RE: Pontilux - 1301 Cuesta Abajo Ct NE

Grading and Drainage Plan

Hydrology File: D16D002H

# GRADING AND DRAINAGE PLAN

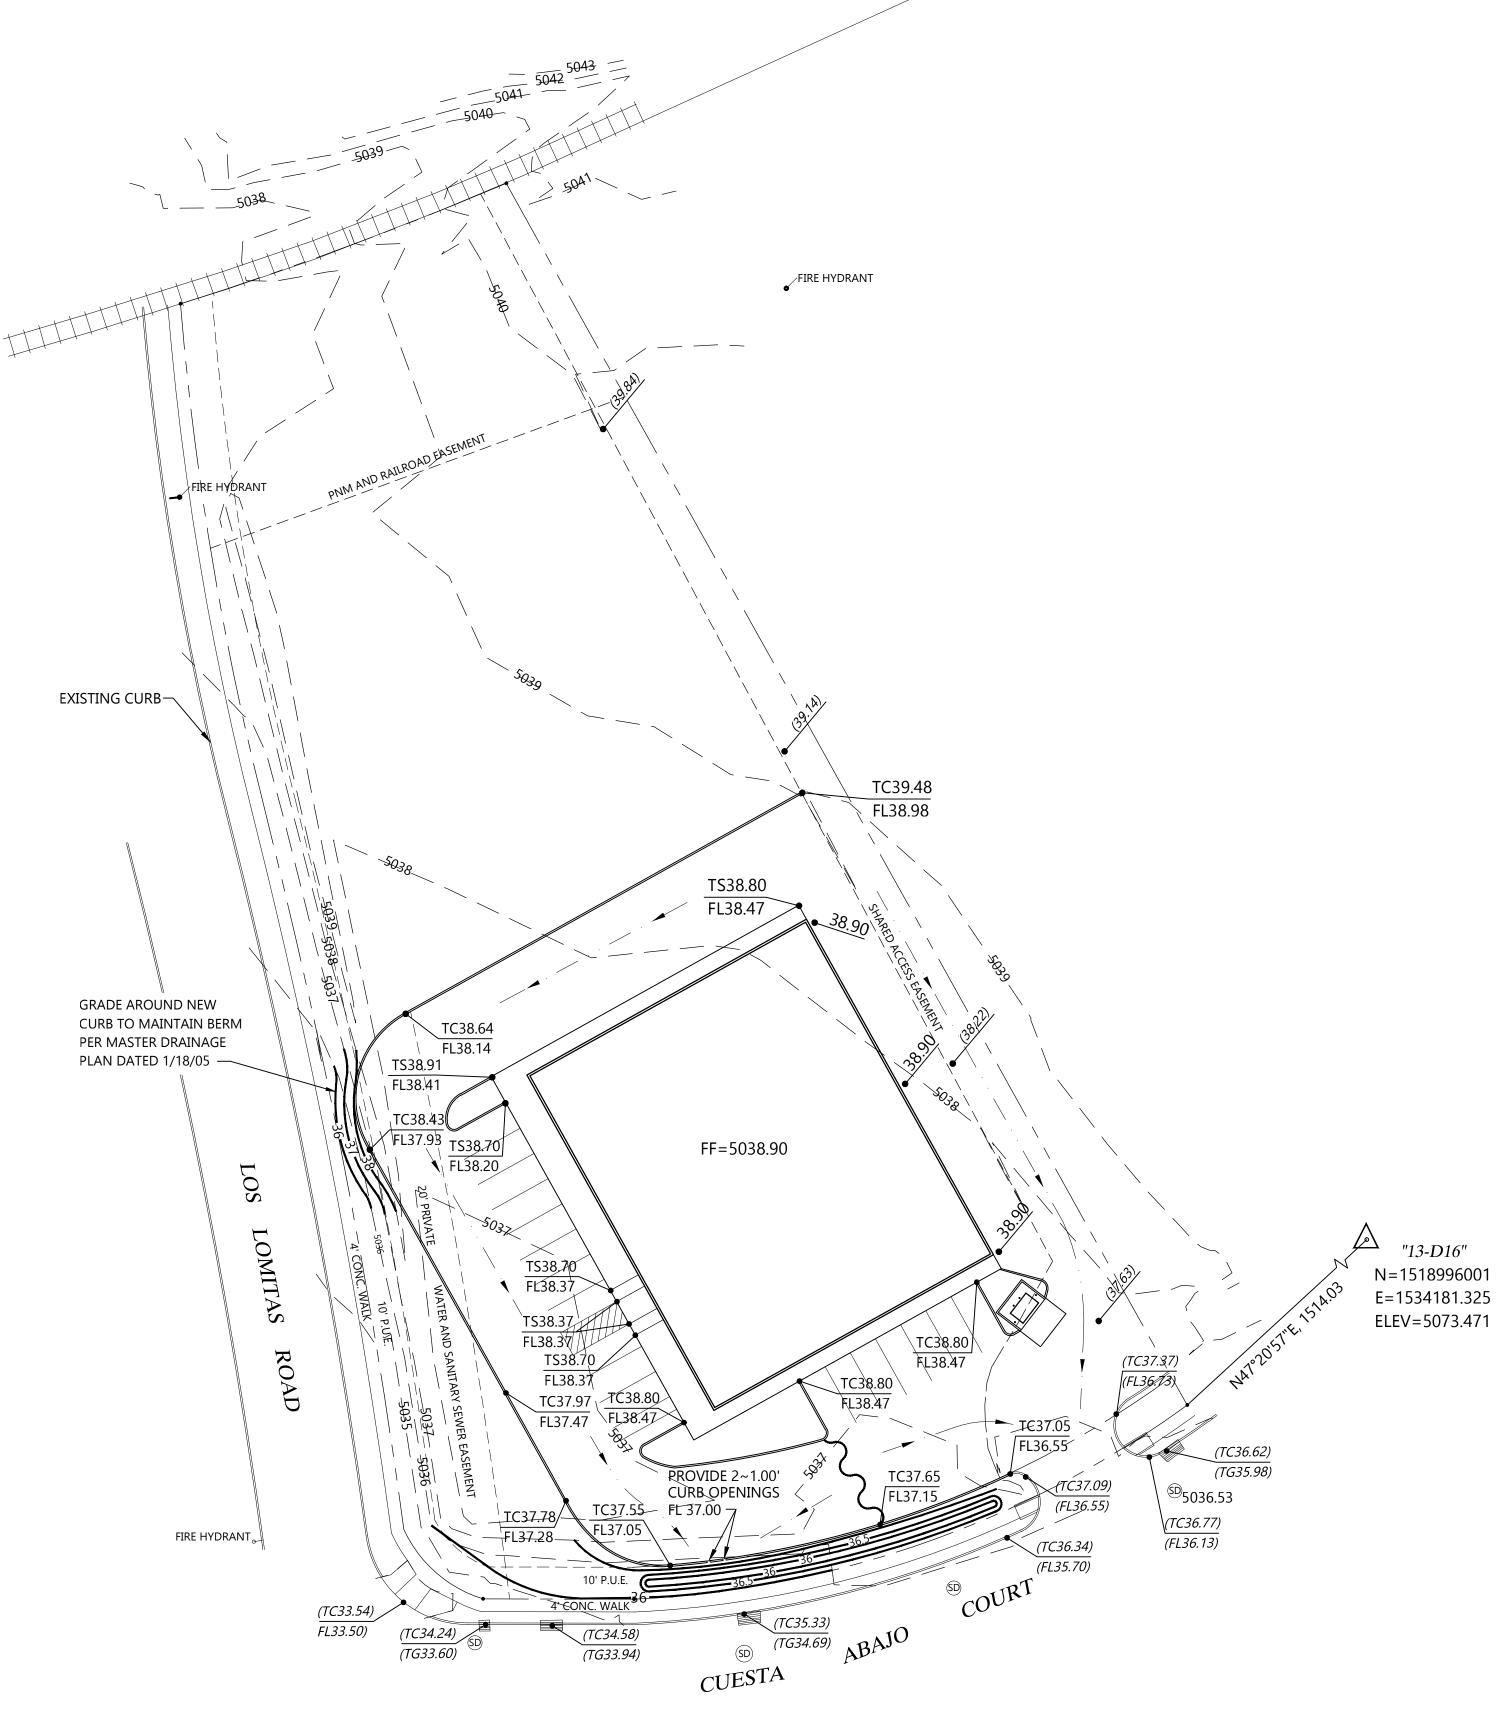
Based upon the information provided in your re-submittal received 5/3/2017, the Grading

Plan is approved for Grading Permit.
